Amendments to the Drawings:

Application No.: 10/849,889
Art Unit: 3617

ANNOTATED SHEET

Fig. 2A

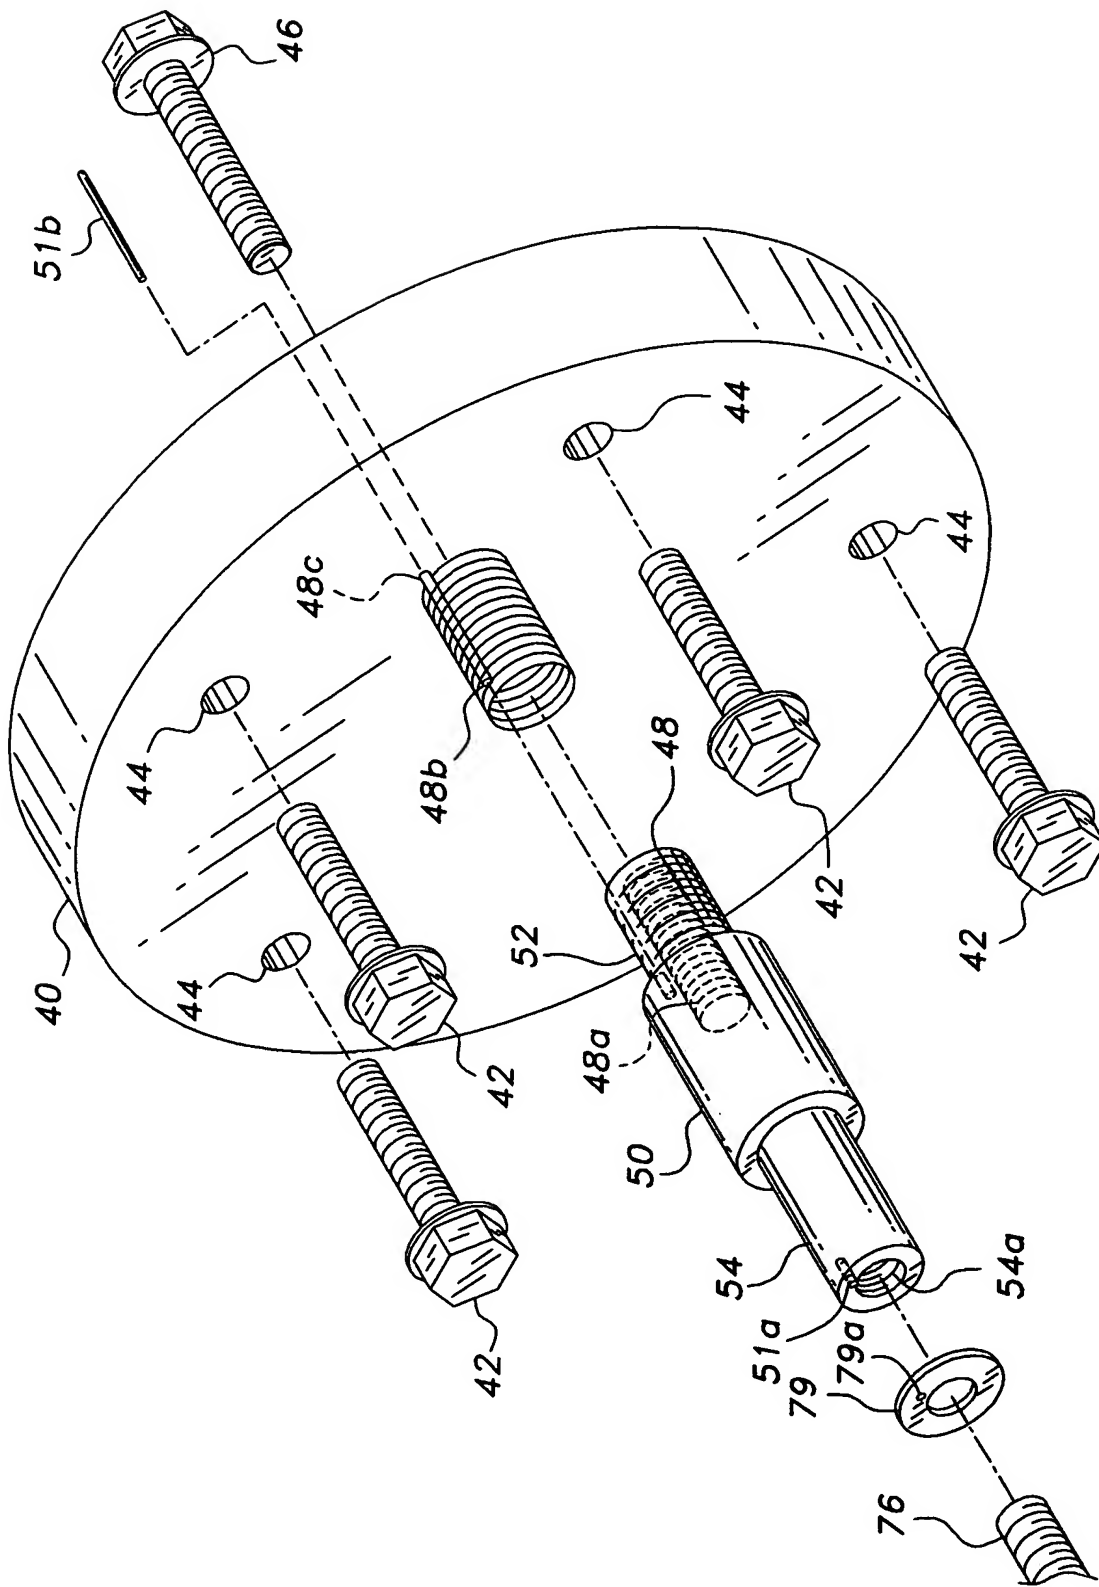
A proposed drawing change is submitted herewith. Proposed changes are shown in red. The attached sheet include changes to Fig. 2A. This sheet, which includes only Fig. 2A, replaces the original sheet including only Fig. 2A. In Fig. 2A, plate **40** including holes **44**, bolts **42** and **46** have been added. Pin **51b** has been exploded to show its pre-assembly position. Reference characters **48a**, **48b**, and **54a** have been added to more clearly show previously indicated threaded surfaces. Reference character **48c** has been added to clearly show an opening for receiving pin **51b**.

In the recent Final Office Action the drawings were objected to under 37 CFR 1.83 (b) as being incomplete. The Examiner held that it was unclear (1) why the external surface of end portion **52** is threaded; (2) how this threaded end could be threaded into the threaded bore in plate **40** since pin **51b** would prevent rotation of shaft **50**; (3) internal threaded bore in end **52** not shown; (4) where pin **51b** is received in plate **40**.

Applicant regrets the lack of clarity in showing these features in the drawings. To this end Fig 2A and the specification have been amended so that these features are clearly illustrated and explained. As shown (1) bore in plate **40** is provided with internal threads **48b** to receive threaded end **52**; (2) pin **51b** is shown exploded from shaft **50**. Pin **51b** is not inserted until after end **52** is threaded into bore plate **40**; the internal threaded bore for end **52** has been designated as **48a**; (4) reference character **48c** indicates an opening (shown in phantom lines) in plate **40** for receiving pin **51b**.
